BARANGAROO SOUTH

Stage 1B Public Domain Modification S4.55 Development Application Report

Mod Application Overview

AVAILABLE SOIL VOLUME

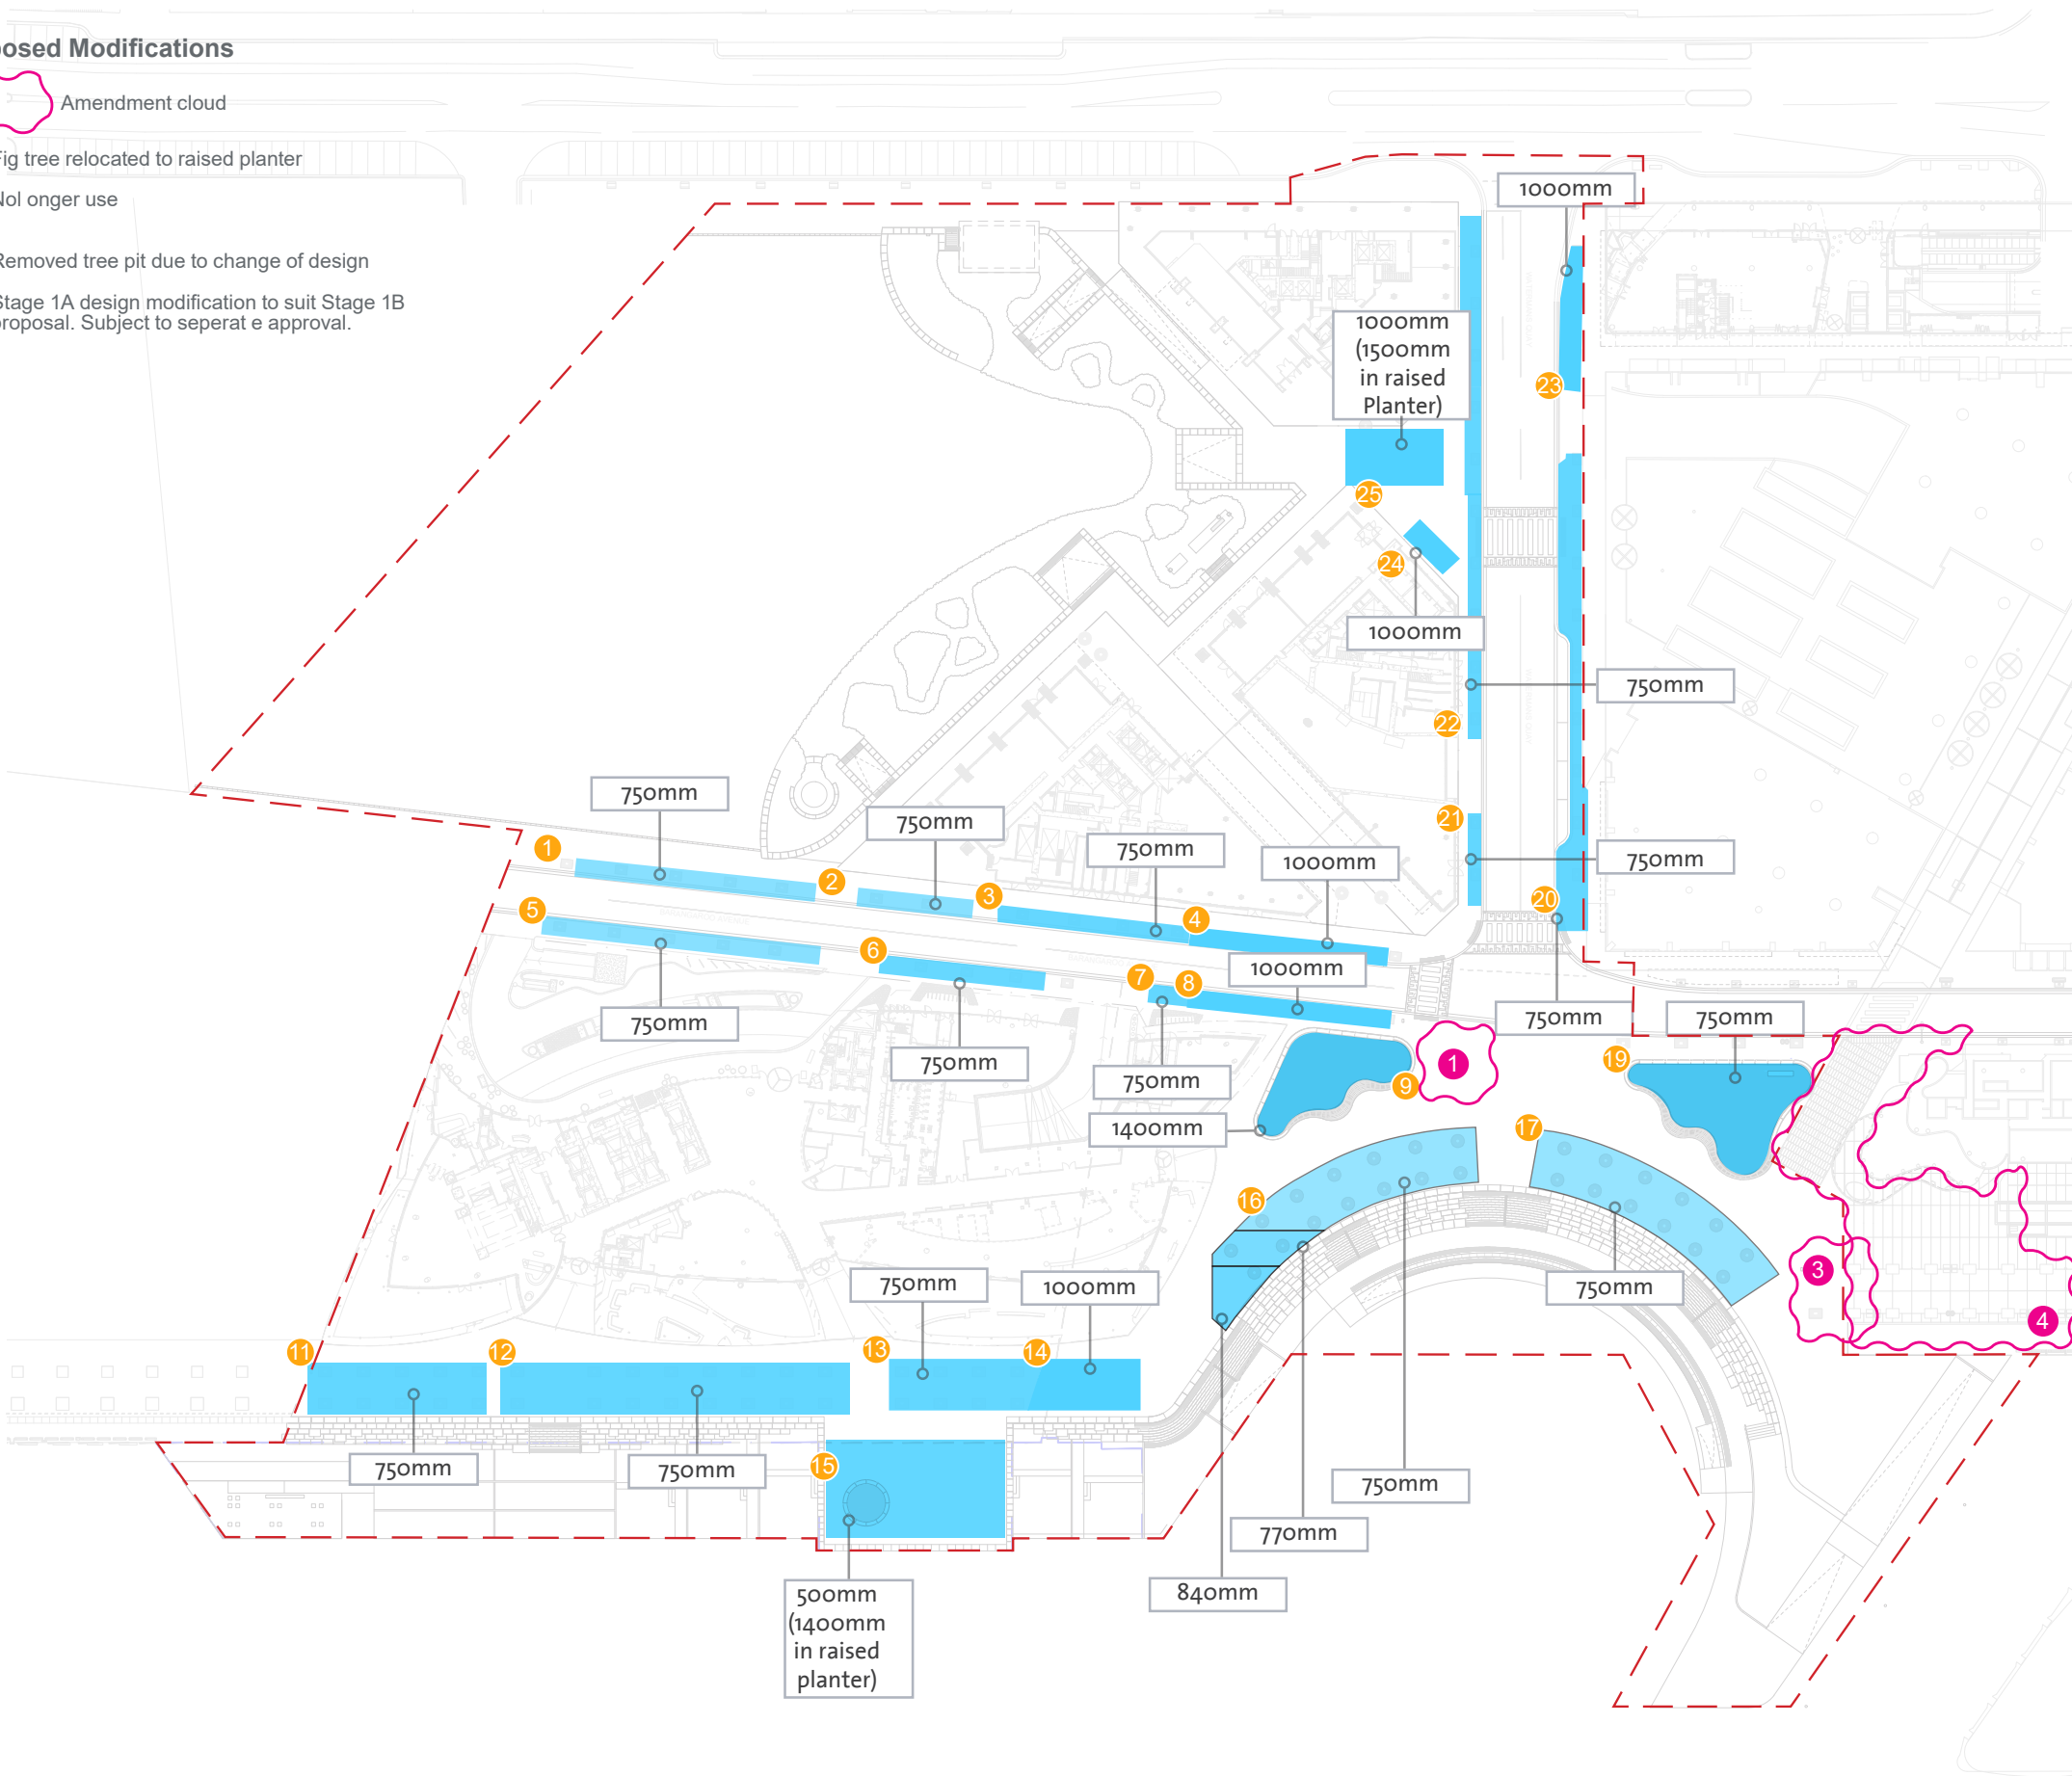
- Amendment cloud
- Fig tree relocated to raised planter
- Nol onger use
- Removed tree pit due to change of design
- Stage 1A design modification to suit Stage 1B proposal. Subject to seperat e approval.

STAGE 1B PUBLIC DOMAIN MASTER PLAN

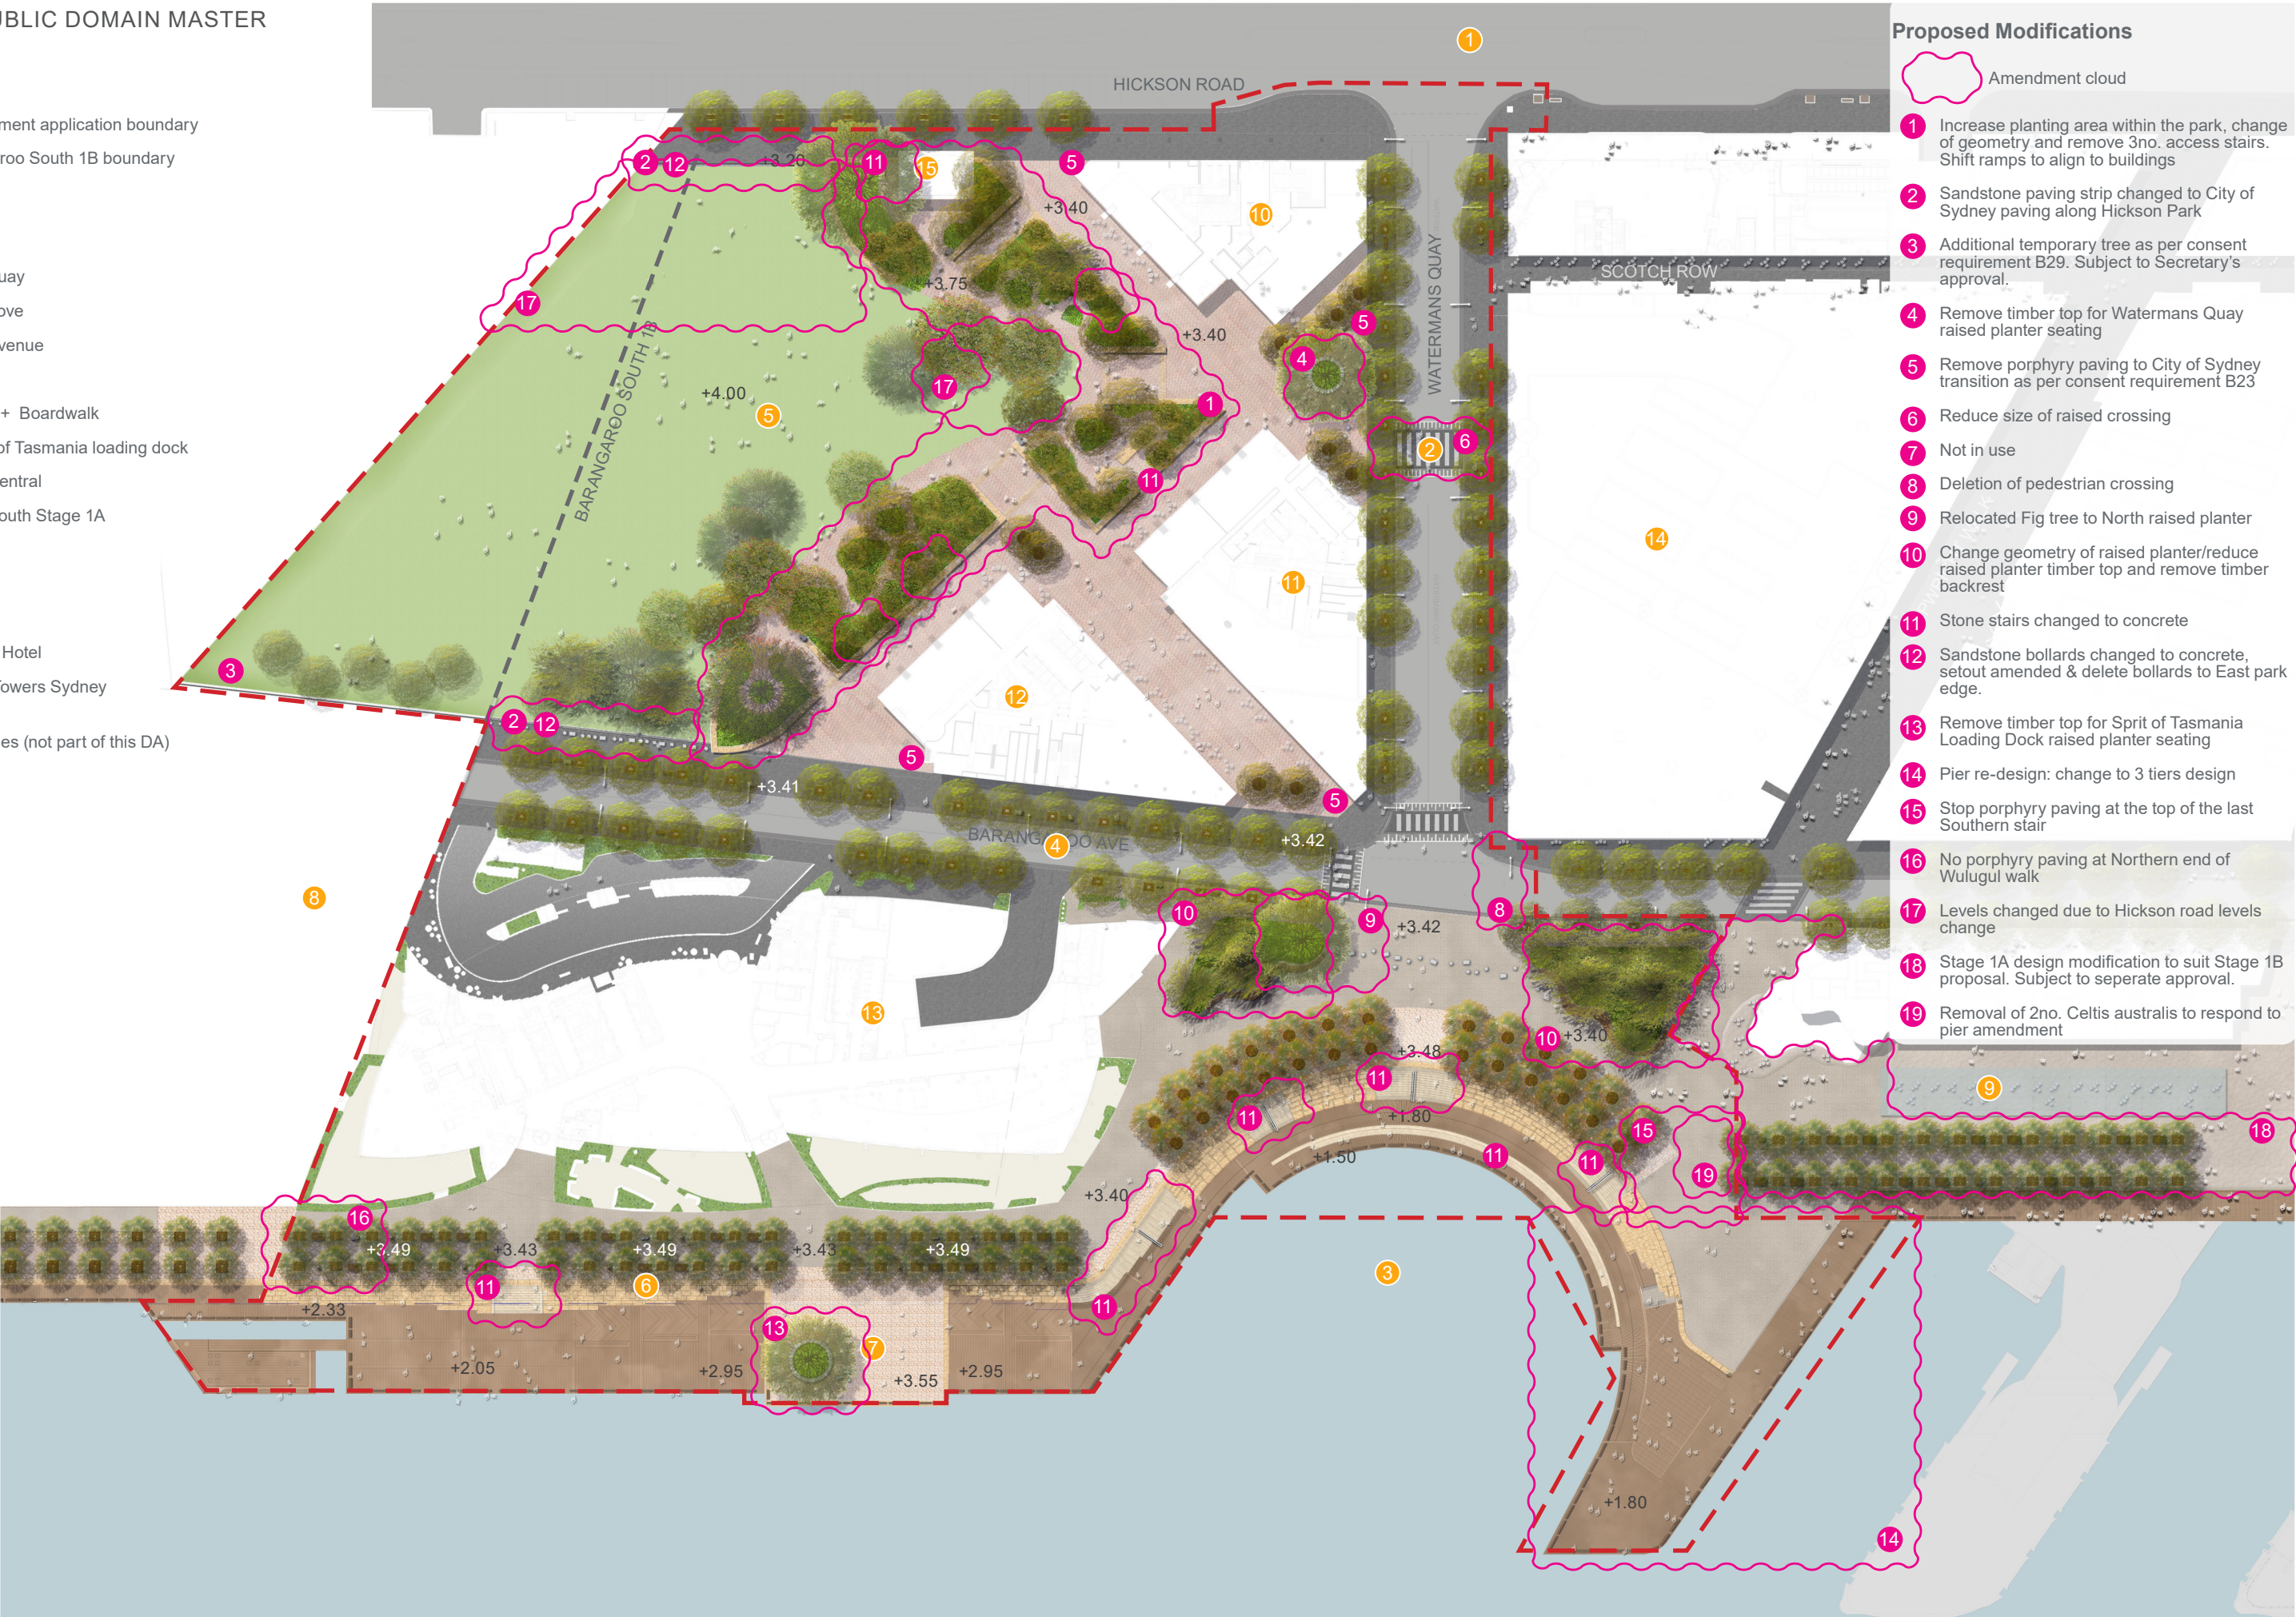
- Amendment cloud
- 1 Increase planting area within the park, change of geometry and remove 3no. access stairs. Shift ramps to align to buildings
- 2 Sandstone paving strip changed to City of Sydney paving along Hickson Park

- 3 Additional temporary tree as per consent requirement B29. Subject to Secretary's approval.
- 4 Remove timber top for Watermans Quay raised planter seating

- 5 Remove porphyry paving to City of Sydney transition as per consent requirement B23
- 6 Reduce size of raised crossing
- 7 Not in use
- 8 Deletion of pedestrian crossing

- 9 Relocated Fig tree to North raised planter
- 10 Change geometry of raised planter/reduce raised planter timber top and remove timber backrest
- 11 Stone stairs changed to concrete

- 12 Sandstone bollards changed to concrete, setout amended & delete bollards to East park edge.
- 13 Remove timber top for Sprit of Tasmania Loading Dock raised planter seating

- 14 Pier re-design: change to 3 tiers design
- 15 Stop porphyry paving at the top of the last Southern stair
- 16 No porphyry paving at Northern end of Wulugul walk

- 17 Levels changed due to Hickson road levels change
- 18 Stage 1A design modification to suit Stage 1B proposal. Subject to seperate approval.
- 19 Removal of 2no. Celtis australis to respond to pier amendment

WATERMANS QUAY MASTERPLAN

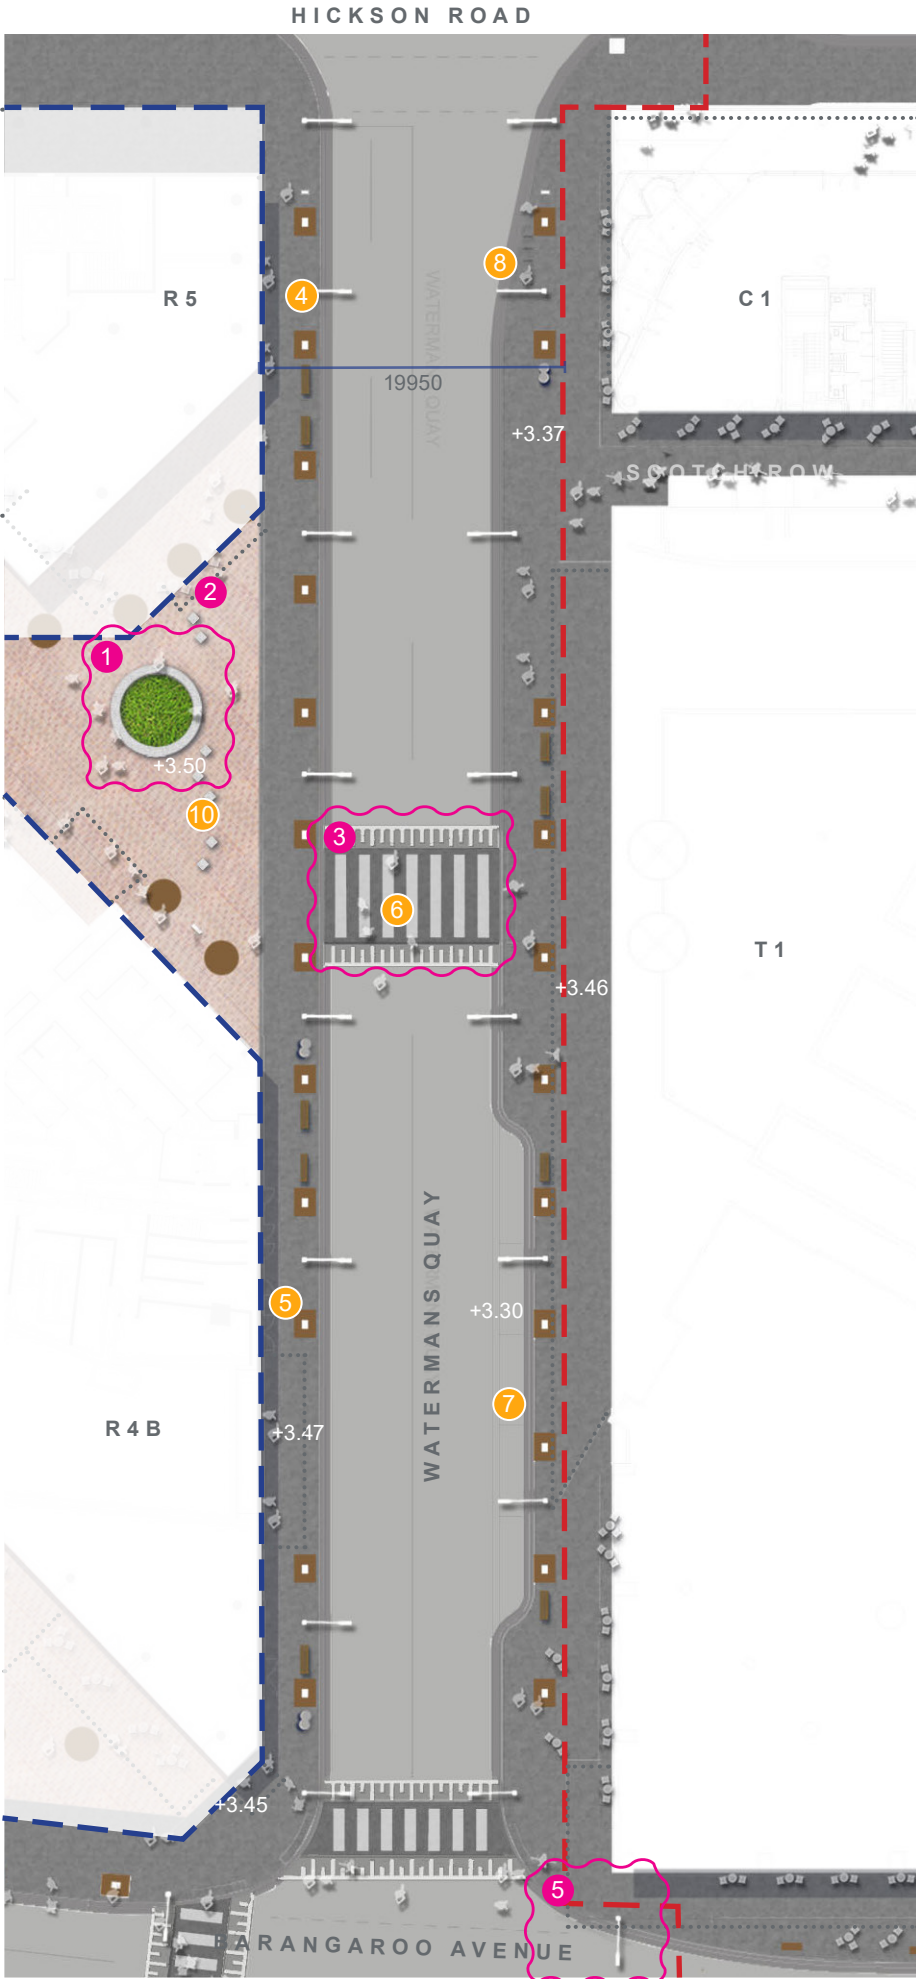
- Amendment cloud
- 1 Remove timber top for Watermans Quay raised planter seating
- 2 Remove porphyry paving to City of Sydney transition as per consent requirement B23
- 3 Reduce size of raised crossing
- 4 Not in use
- 5 Deletion of pedestrian crossing

WATERMANS QUAY DETAIL PLAN

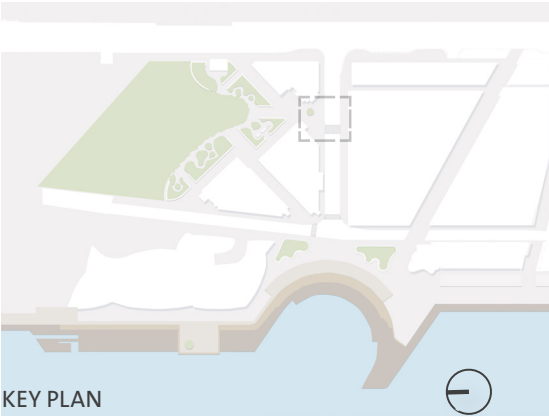
- Amendment cloud
- 1 Remove timber top for Watermans Quay raised planter seating
- 2 Remove porphyry paving to City of Sydney transition as per consent requirement B23
- 3 Reduce size of raised crossing
